UNITED STATES PATENT AND TRADEMARK OFFICE

APPLICATION NO.	FILING DATE	FIRST NAMED INVENTOR	ATTORNEY DOCKET NO.	CONFIRMATION NO.
10/696,216	10/28/2003	Paul T. Wingett	H0004820	7323

Office Action Summary

ATTACHMENT

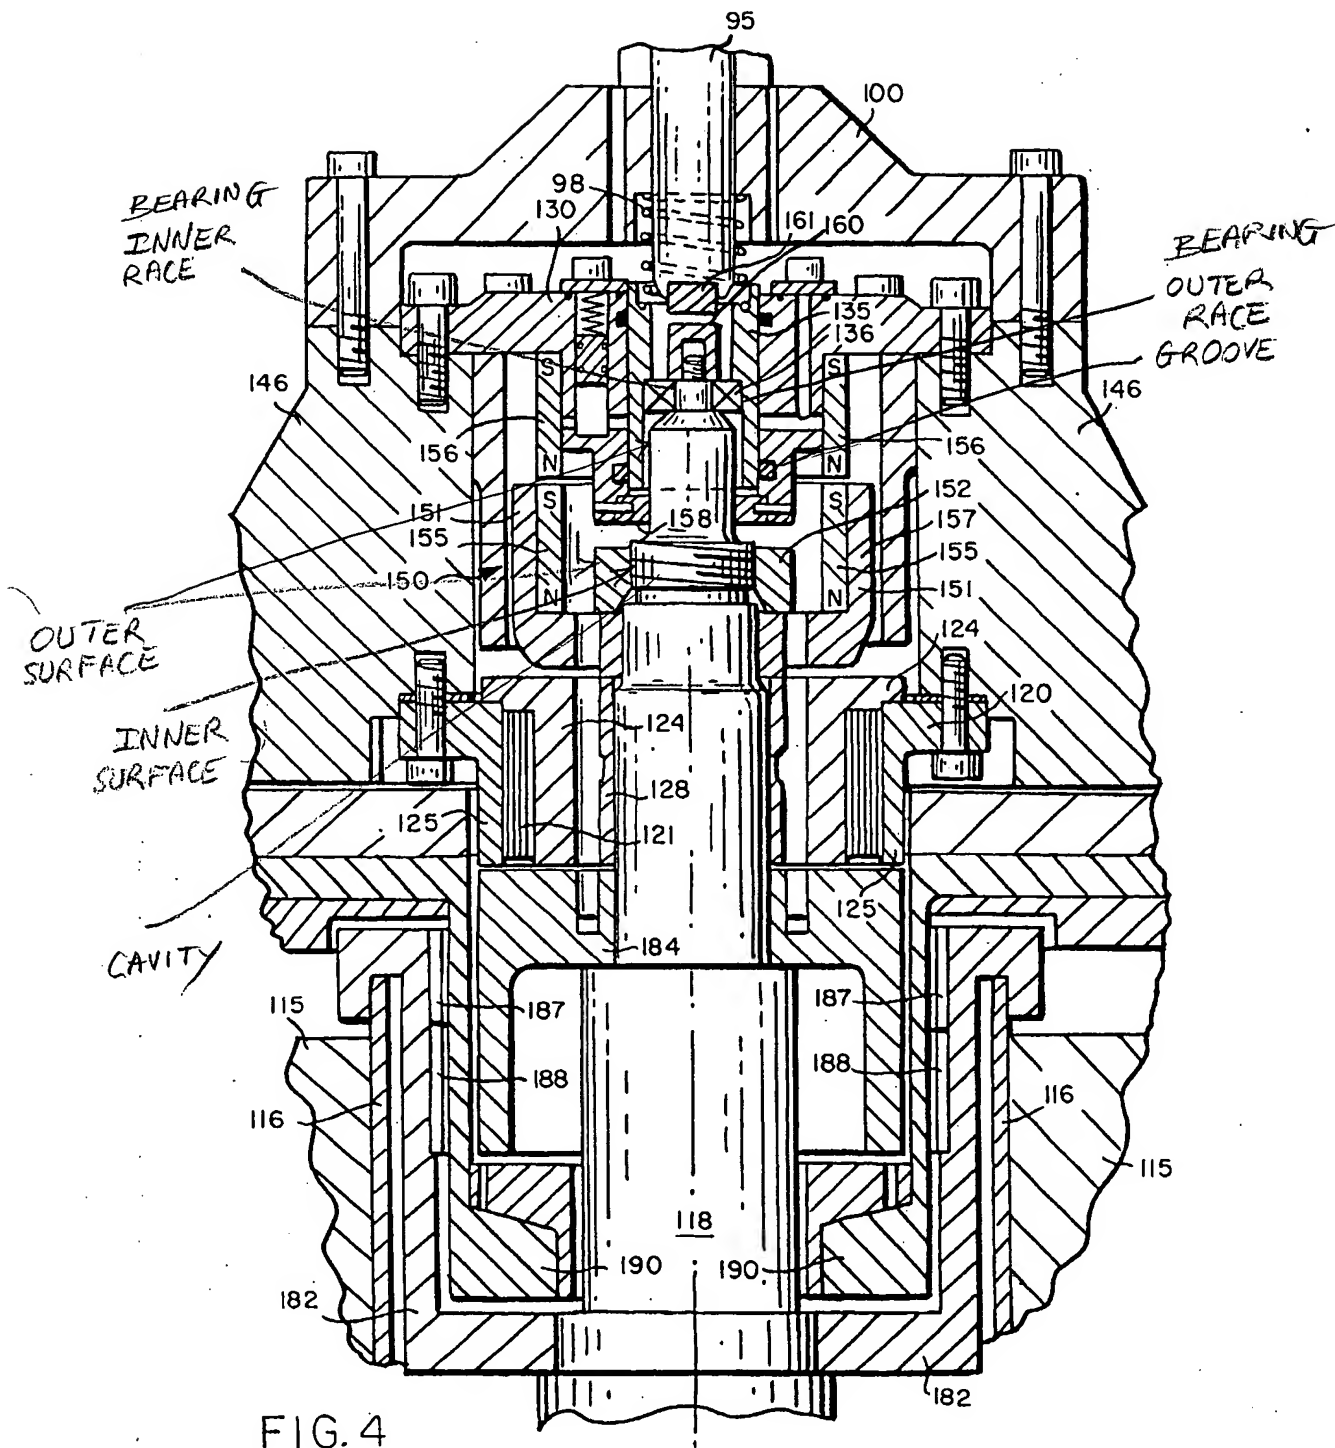
Regarding claim 7, Hockney teaches a bearing assembly (Figs. 4, 5, and 7) for selectively engaging a shaft 118, comprising:

a bearing 136 having at least an inner race and an outer race (unnumbered in Fig.

4. *Ibid.* column 5, lines 11-31. See Attachment or “Att.”);

a bearing mount 152, 158 coupled to the bearing inner race (Att.);

a sleeve 135 having at least an inner surface (Fig. 5, Att.), an outer surface (Att.), first and second ends (Att.), at least a portion of the sleeve inner surface (Att.) coupled to the bearing outer race (Att.);

one or more resilient seals 132, 133 coupled to the sleeve outer surface (Att.); and

one or more preload springs 98 (Fig.4) coupled to one of the first and second sleeve ends (Att.). See, e.g., column 4, lines 48-61.

a touchdown cup 158, 152 having at least an outer surface (Fig. 4, Att.) and an inner surface (Att.) that defines a cavity (Att.), the touchdown cup outer surface (Att.) coupled to the bearing assembly inner race (Att.), the touchdown cup cavity (Att.) surrounding at least a portion of the shaft 118 and dimensioned, upon translational movement of the bearing assembly mount 152, 158 to selectively engage the shaft 118. Ibid. column 4, line 48 through column 5, line 10.

one or more auxiliary bearing assemblies (i.e., a touch down bearing) disposed within the housing assembly 45, each auxiliary bearing assembly configured to selectively rotationally support the shaft 18, 118 and including:

a bearing 136 having at least an inner race (Att.) and an outer race (Att.),

a bearing mount 152, 158 coupled to the bearing inner race (Att.), the bearing mount 152, 258 disposed adjacent to, and configured to selectively engage and disengage, the shaft 18, 118,

a sleeve 135 having at least inner and outer surfaces (Att.), first and second ends (Att.), at least a portion of the sleeve inner surface (Att.) coupled to the bearing assembly outer race (Att.) and at least a portion of the sleeve outer surface (Att.) coupled to the housing assembly 45 (by a plate 131),

one or more resilient seals 132, 133 coupled between the sleeve outer surface (Att.) and the housing assembly 45, and

one or more preload springs 98 coupled between the housing assembly 45 and one of the first and second sleeve ends (Att.).
